Submissions by Location – Click on title to be ‘hyperlinked’ to the relevant page

C90 general

PLANNING SCHEME AMENDMENT C90

0 25 50 100 Meters

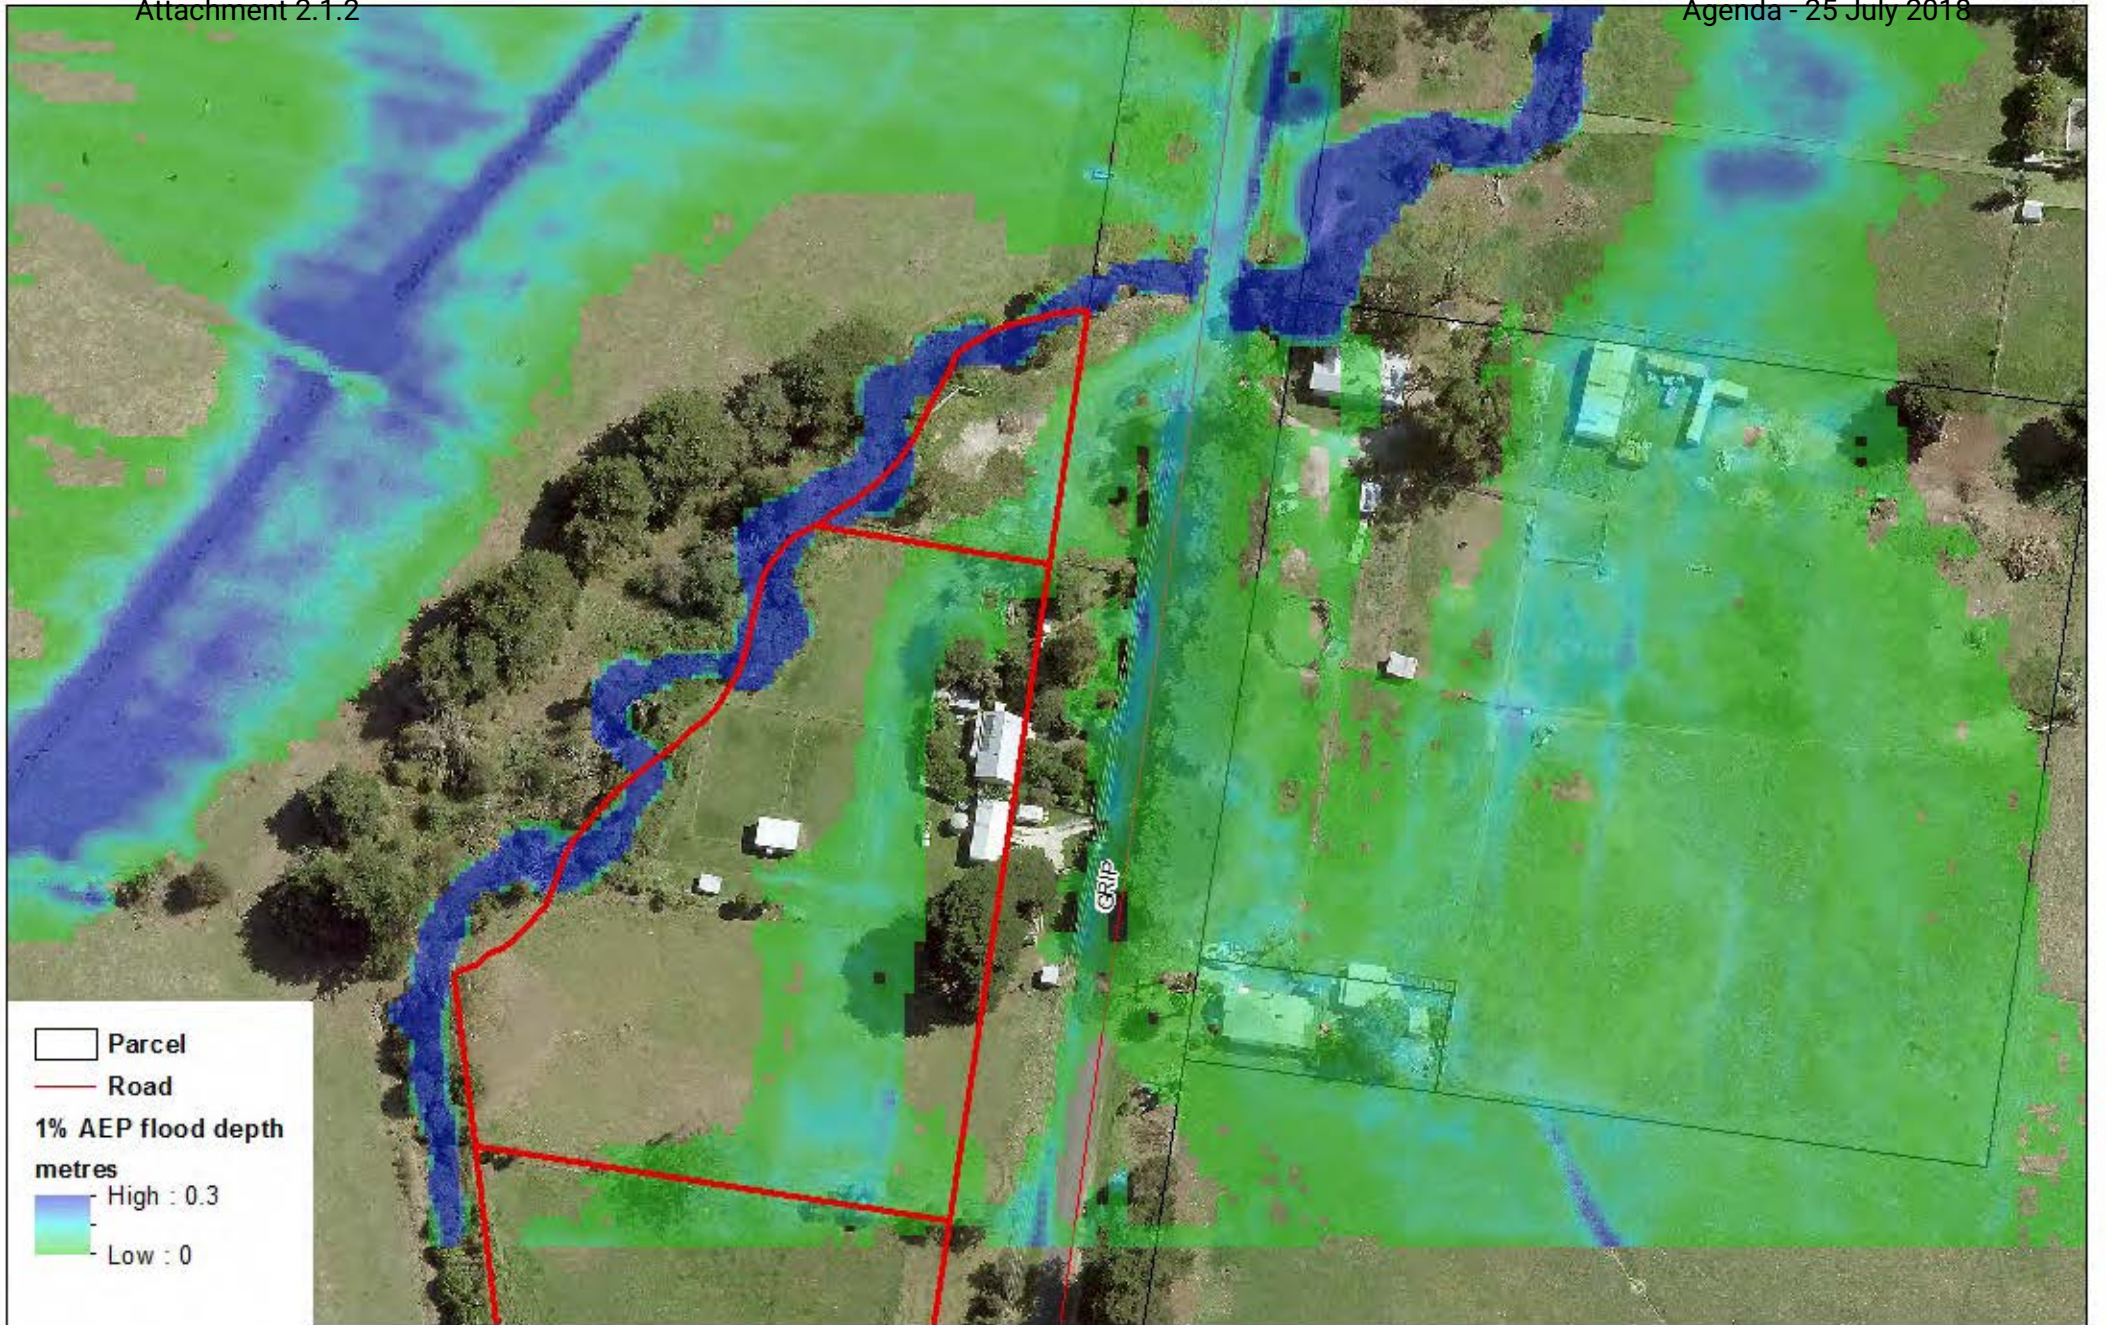
(Note – plans attached have land subject to 0.3m or greater flood depth shaded blue. This is based on LiDAR and not detailed survey).

1. Lot 5 - You are correct and this was an oversight on my part as the LSIO is slightly more extensive over the north east corner of this lot than our estimated 1% AEP flood extent. Based on our estimated 1% AEP flood extent, there is an area of approximately 1800 sqm (which may be refined if detailed survey were undertaken) that meets our criteria as shown in the attached map. The summary table for Port Welshpool has been updated (with changes to Lot 5 only) below.

2. Lot 4 - The area that meets our criteria is shown in the attached plans (at different scales) and corresponds with the LSIO.
3. Lot 16 - The area that meets our criteria is shown in the attached plan and corresponds with the LSIO. On CA 15 and 15A, development would only be supported where both it and its access are subject to < 0.3m flood depth (shaded green) and public access would need to be created for CA 15.

4. For all of the lots other than 23 and 24, as per the summary table for Toora, we'd support dwellings where both the dwelling and access are outside the LSIO. As you have access to the LSIO, I haven't created a plan of each of the lots. However there is no LSIO around Lots 23 and 24 so I have attached plans for each of those lots showing the area that meets our criteria. The flood modelling we've done does not cover the entire lots (which is why there is a sharp boundary to the flood depth layer in the maps) and we'd include the un-modelled land in the area which is appropriate for development. Any land shaded blue doesn't meet our criteria, but anything else – whether shaded green or not modelled - does.

Figure 1: Outline of area requested to be considered for Rural living and increased Residential areas

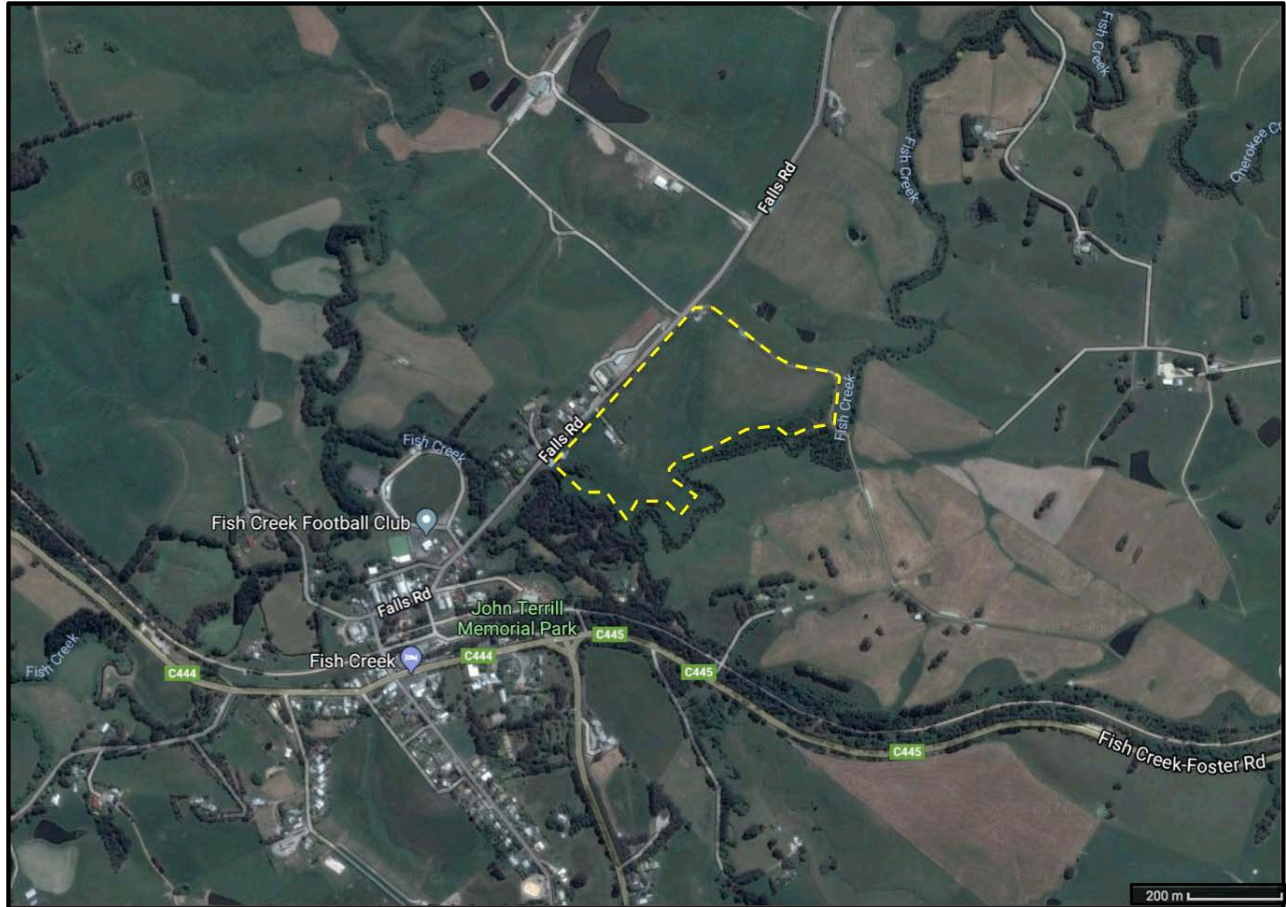
The subject land is located at 1055 Falls Road in Fish Creek, adjacent existing residential areas and less than 1 kilometre north east of the Fish Creek town centre. It is known as Lot 2 on Plan of Subdivision 416713. The lot is in two parcels which are intersected by a creek; the entire northern portion has the total area of 27 hectares. We are requesting that part (approximately 10 hectares) of the northern parcel be considered within Amendment C90 (Figure 1).

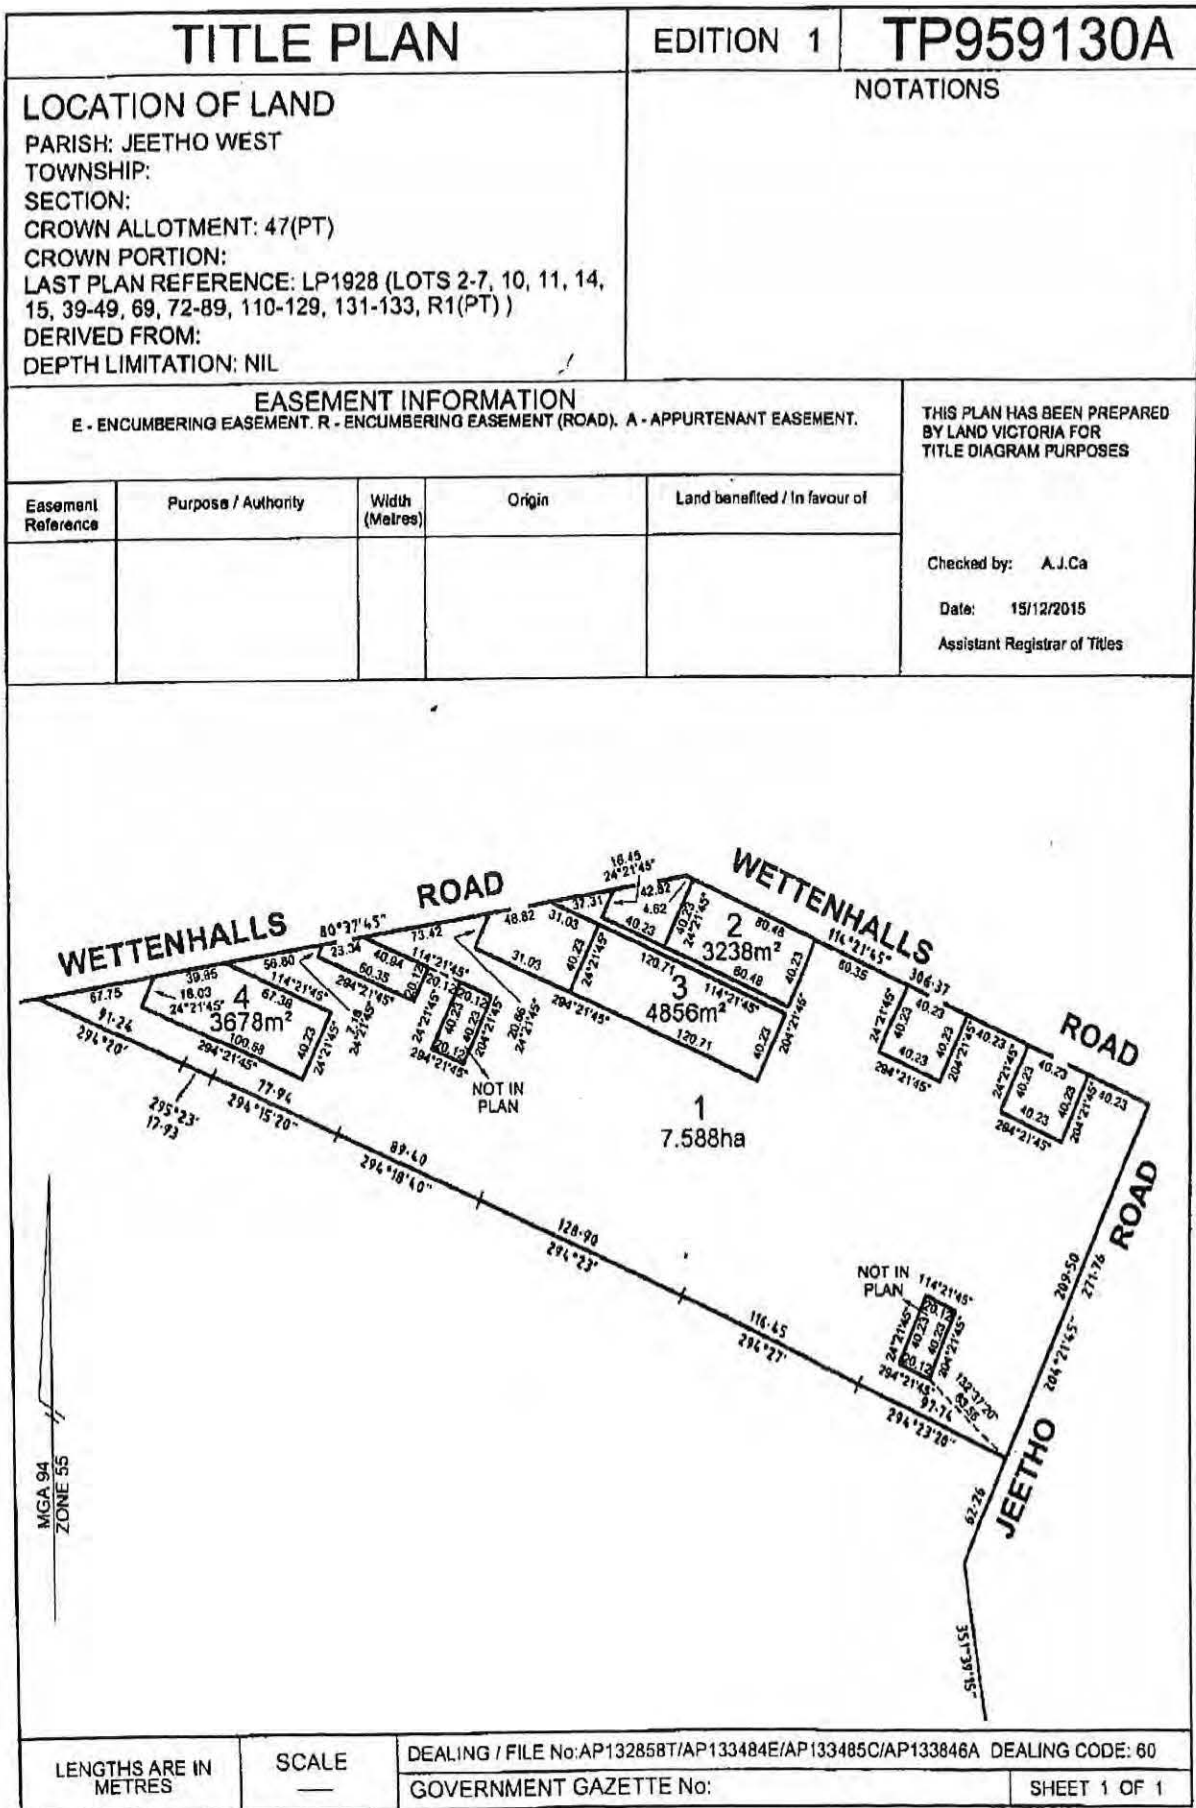
- We would like to see the boundary between the restructured lots 1 and 2 relocated Slightly to be in a more practical position which would be along the line of the eastern boundaries of lots 2 and 3 on TP959130A (attached). This will allow both restructured lots to use existing crossovers and create parcels of more balanced land areas (restructured Lot 1 – 5.06 hectares and restructured Lot 2 – 4.63 hectares).

Please find attached copy of the C90 report showing the suggested amendment in red, together with a copy of TP959130A and a copy of plan showing relevant lots on LP1928 which are all separately titled.
